Land South and East of Adastral Park, Ipswich
Proposed Western Signalised Access
A12 Dual Carriageway

Stage 1 Road Safety Audit

Adastral Park, Ipswich : Off-site Highway Mitigation to Foxhall Roundabout

Technical Note : Designer's Response to Road Safety Audits at Stage 1

10391-H-0L-07 rev A	Proposed Western Signalised Access off A12 Dual Carriageway
---------------------	---

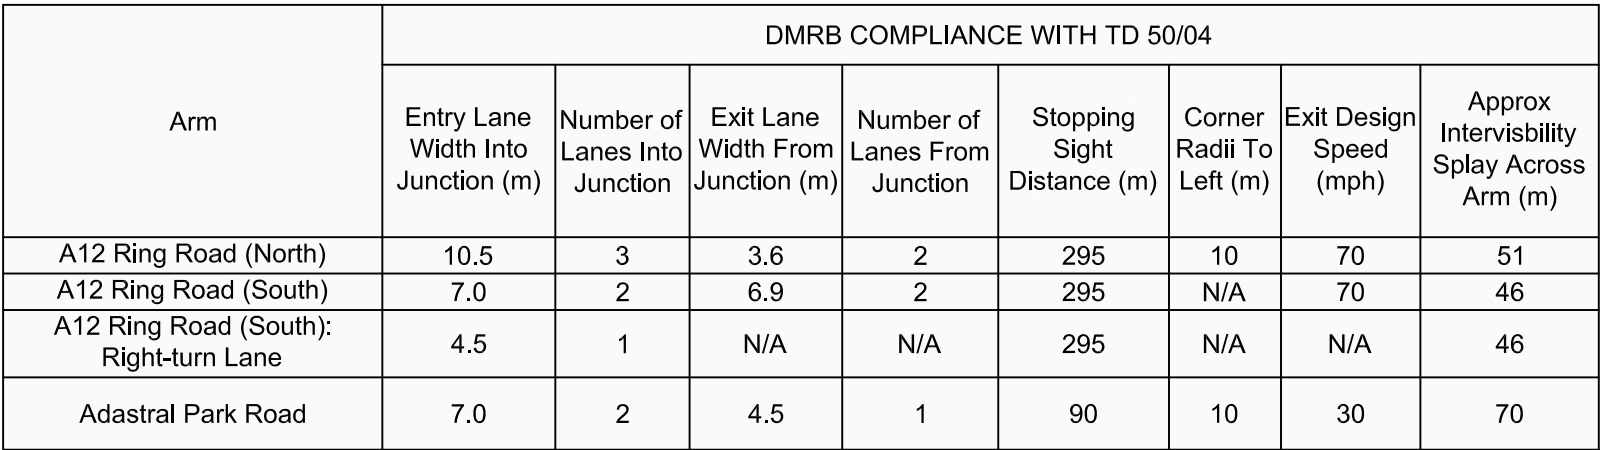
Summary: Risk of kerb strikes.

The tie in at the exit from the signals is acute and could result in vehicles hitting the nearside kerb.

The current crossing point for horses looks unused, which is probably due to the very busy A12. However, the proposed formal crossing may encourage use of this route. However the route is very convoluted, involving stopping the horse several times in the face of traffic.

The stagger for the crossing is the wrong way round which means that the horses and riders will be approaching the crossing with their back to traffic. This may frighten the horses if they are not expecting vehicles to pass them at speed from behind. It also means that pedestrians will not be observing traffic on approach to the crossing and make errors of judgement if crossing against the lights.

The path to and from the crossing on the west side of the A12 is adjacent to the carriageway. As much segregation from the traffic as possible should be provided.

Problems 2.1 and 2.5 not identified on drawing.

Figure 2a: Approach from Foxhall Road into Roundabout

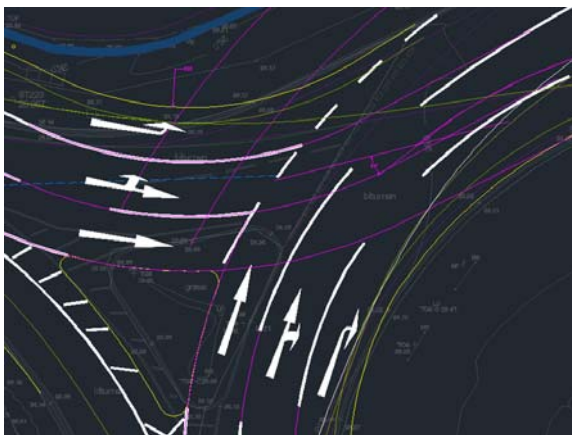
Summary: Risk of collision with central island and sideswipes. The extension of the arc from the splitter islands guides drivers into the circulatory island and to an extent the resultant alignment of the central lanes also guides drivers towards the central island, risking poor lane discipline.

Recommendation: Realign the splitter islands so the extension of the arc is tangential to the circulatory island and make associated amendments to the central lane markings.

BCL Response: *This is already the case as demonstrated in the screen captures in Figures 2a and 2b for the aforementioned roads.*
